### NEEDHAM PLANNING BOARD

### Tuesday November 16, 2021 7:00 p.m.

7:20 p.m. Amendment to Major Project Site Plan Special Permit No. 2009-06: Town of Needham, 1471

8:30 p.m. Major Project Site Plan: Needham Enterprises, LLC, 105 Chestnut Street, Suite 28, Needham,

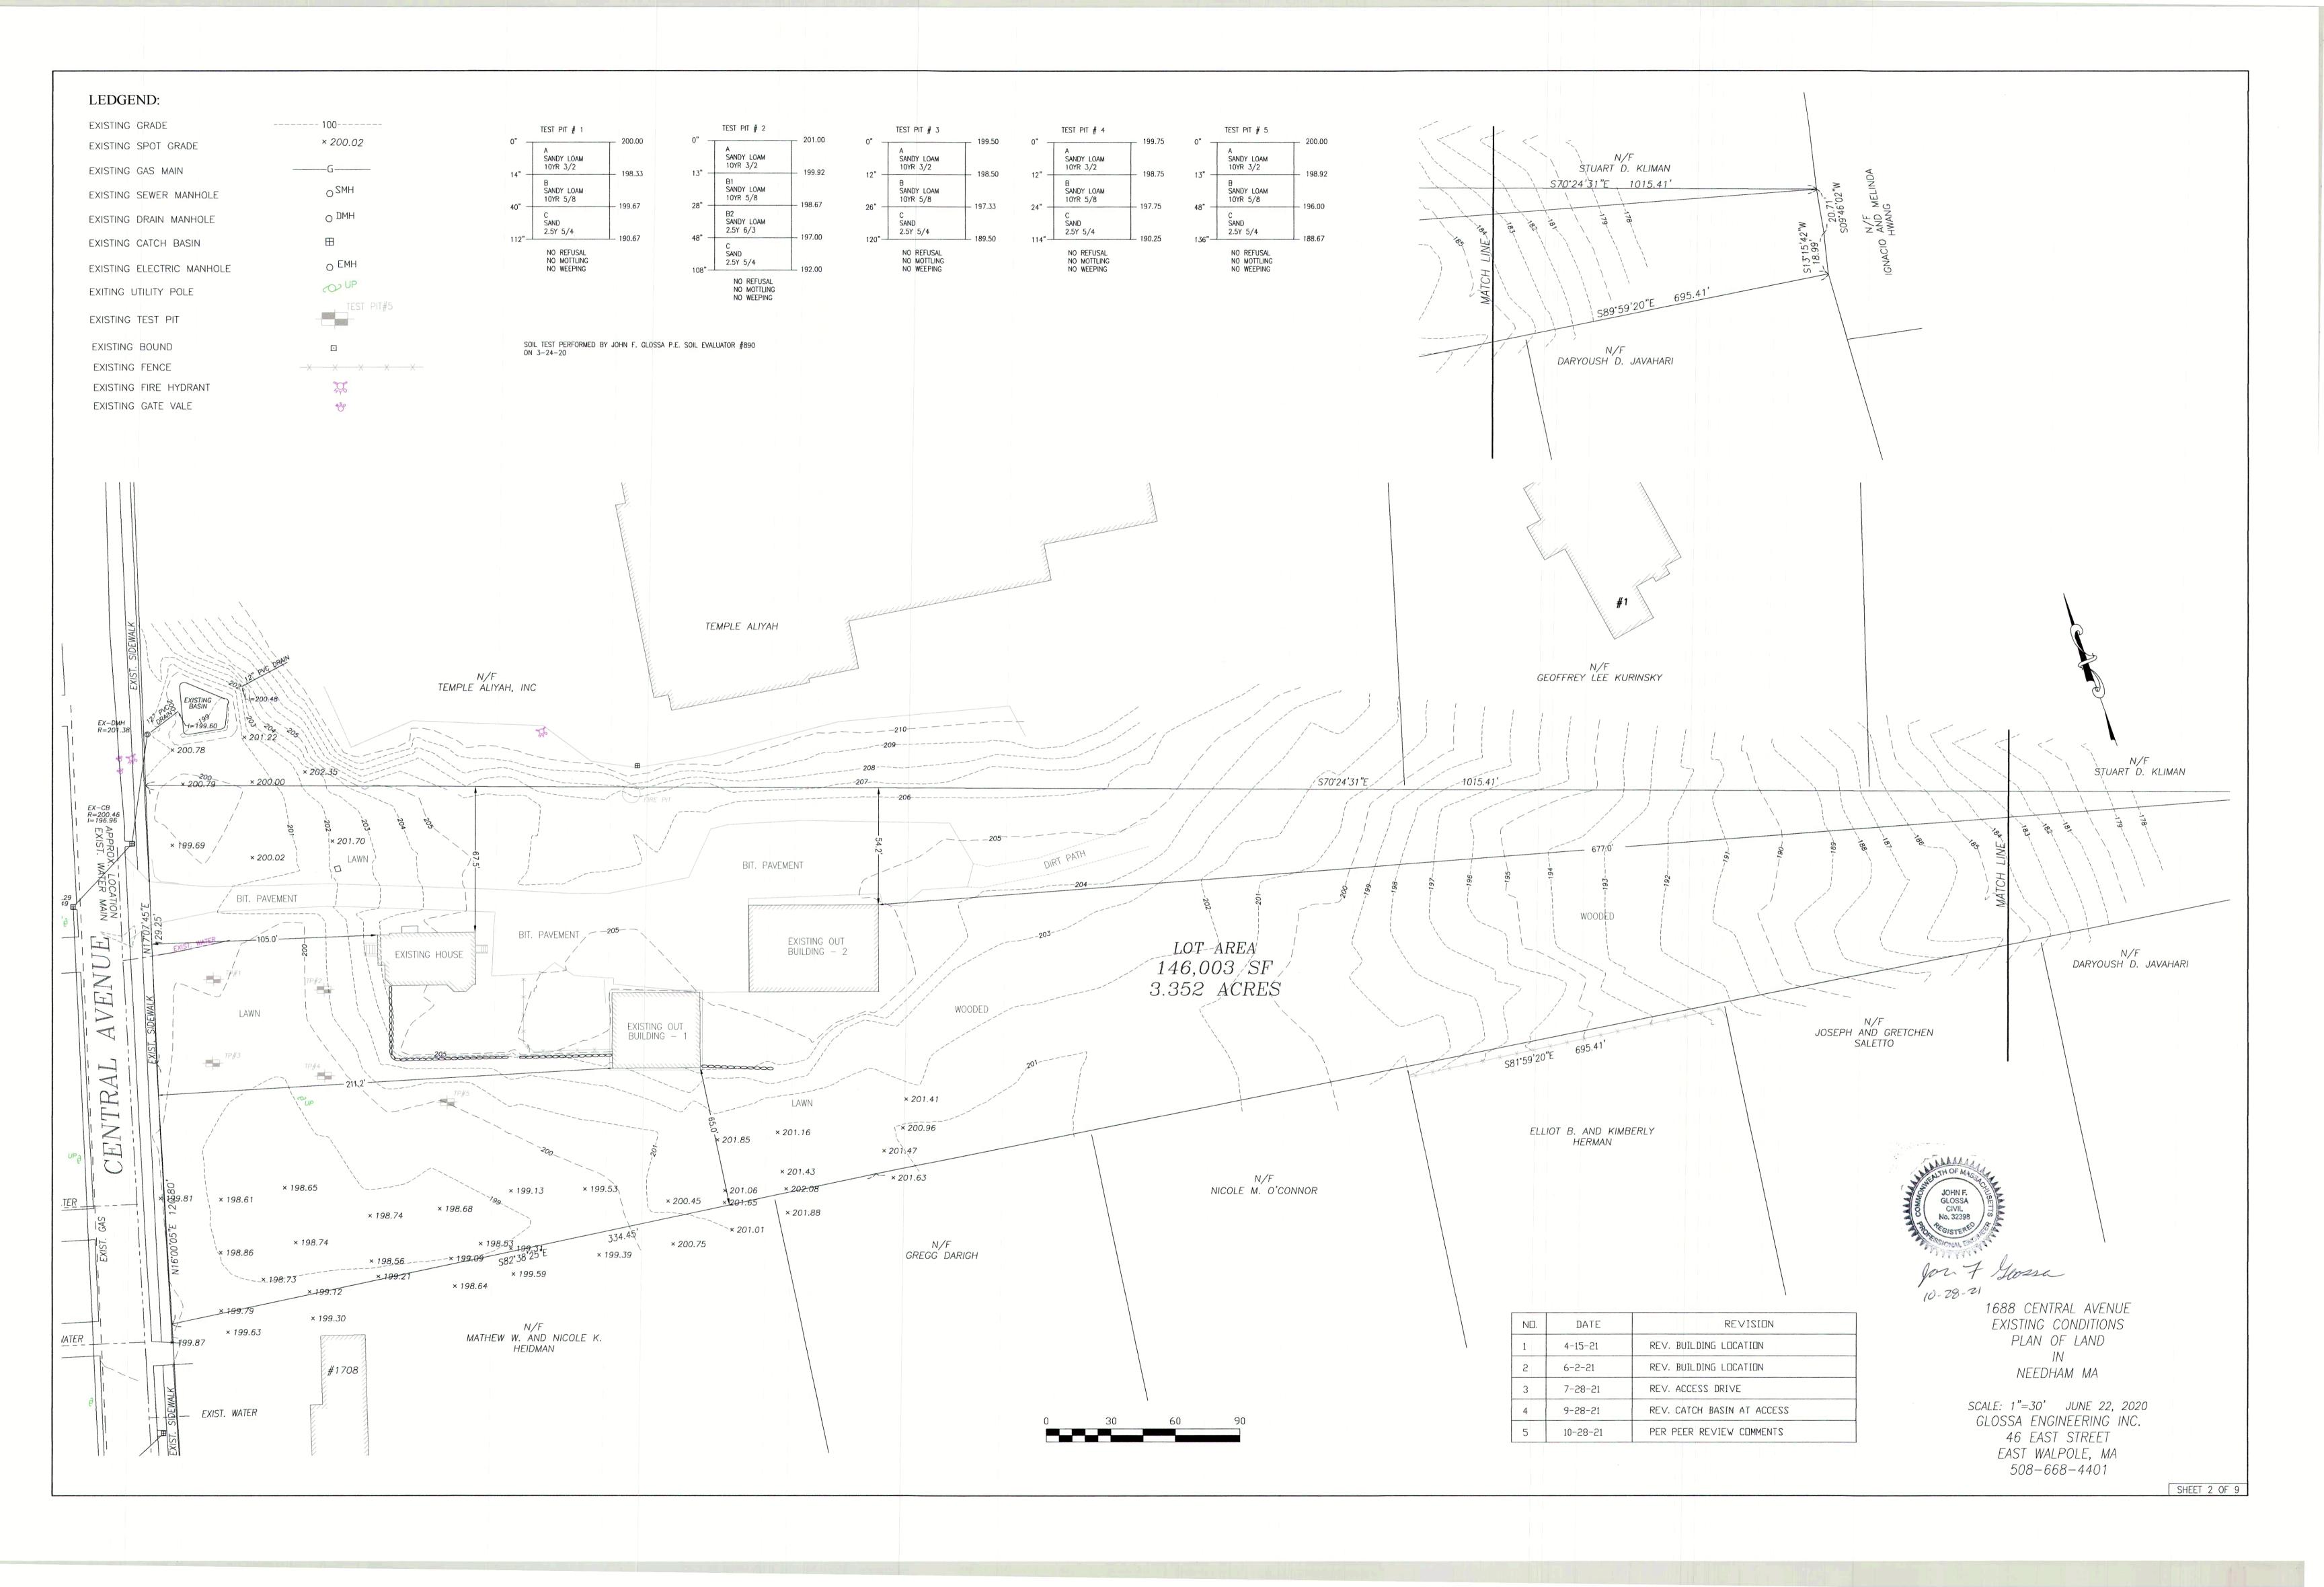
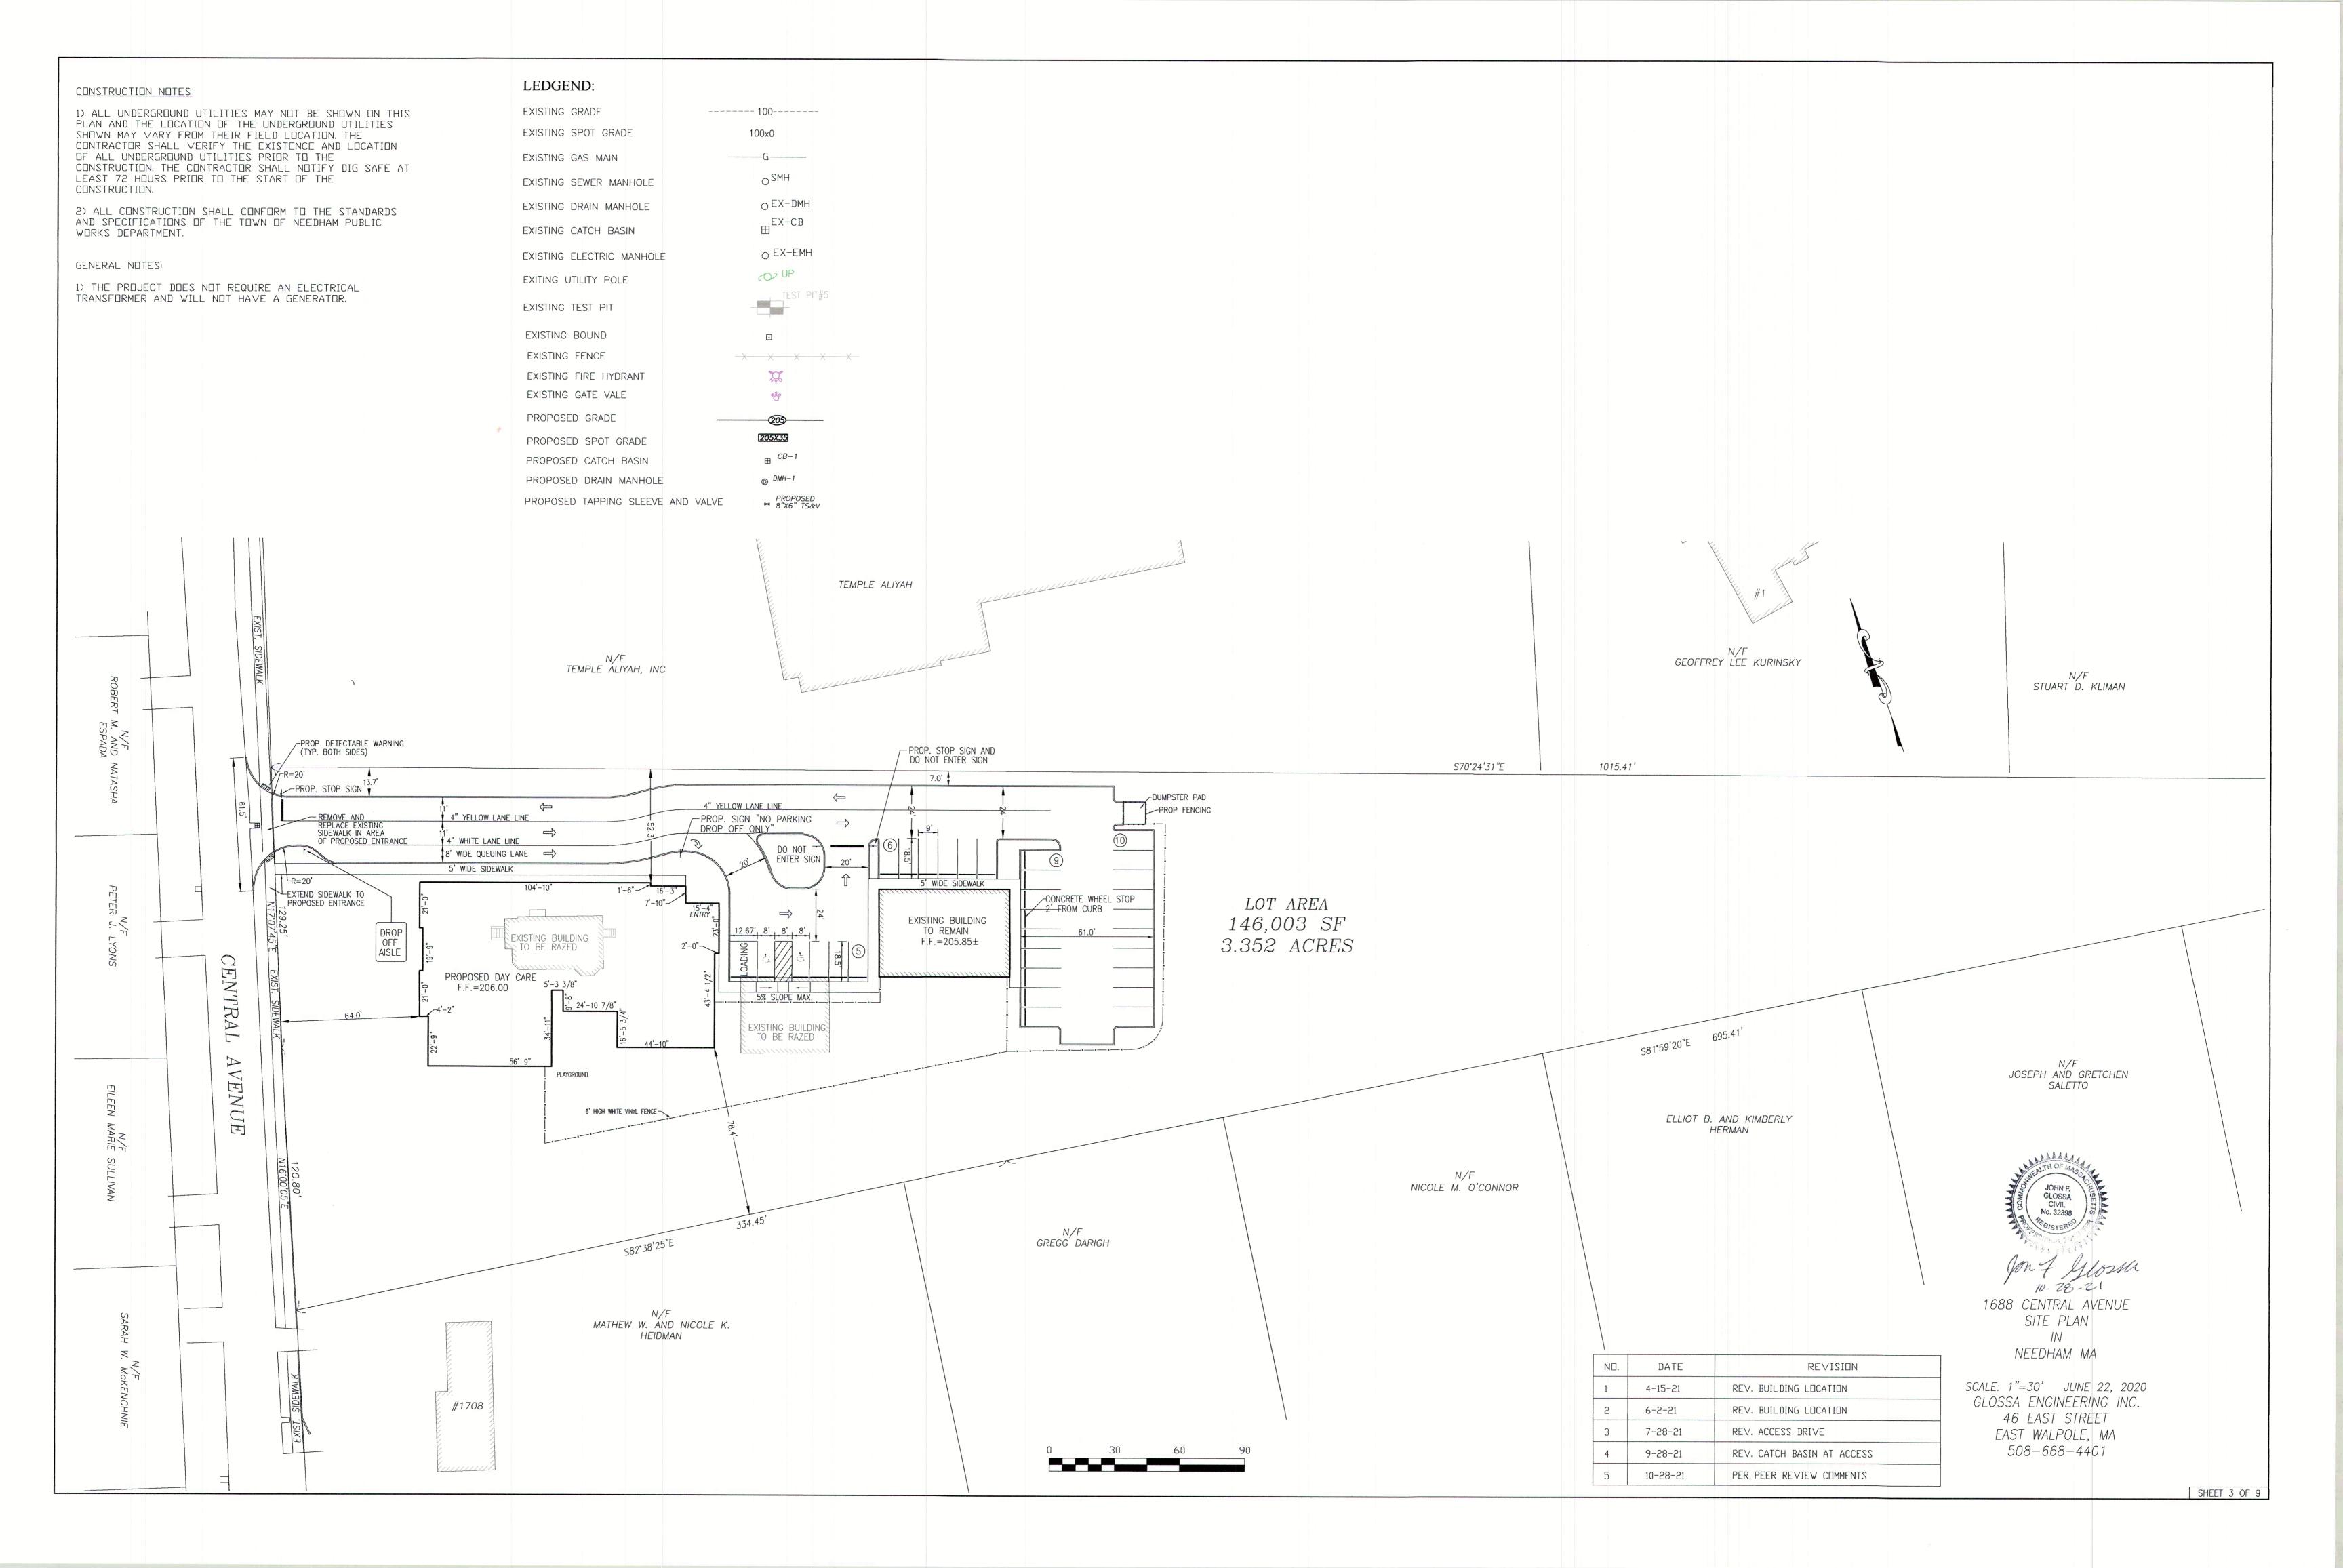
- a) Sheet 4 Proposed grades of the centerline of the driveway apron do not make sense. It appears to slope DOWN from the edge of road to the front of crosswalk by more than 2% and then slope up to the back of the crosswalk by more than 4%

- b) <u>Sheet 4 The spot grades 200x68 and 200x74 indicate the apron slope of about 1% UP at the sidewalk openings and a 1.8%-2.0% slope across the sidewalk/crosswalk, the apron portion should be sloped greater than the crosswalk portion.</u>

- c) Provide grades on sidewalk approaching driveway. It is unclear if the sidewalk slopes to the driveway or is level with the crossing.
- d) Sheet 4 Limit of work on the sidewalks should be indicated (also relates to Comment 2)

- e) Sheet 6 Detail should be provided for the proposed driveway apron.
- Sheet 8 & 9 Proposed CBs should be labeled and Existing CB to be removed should be labeled

- g) Sheet 10 Either delete labels on CBs (not relevant for lighting) or correctly label the Existing CB to be Removed
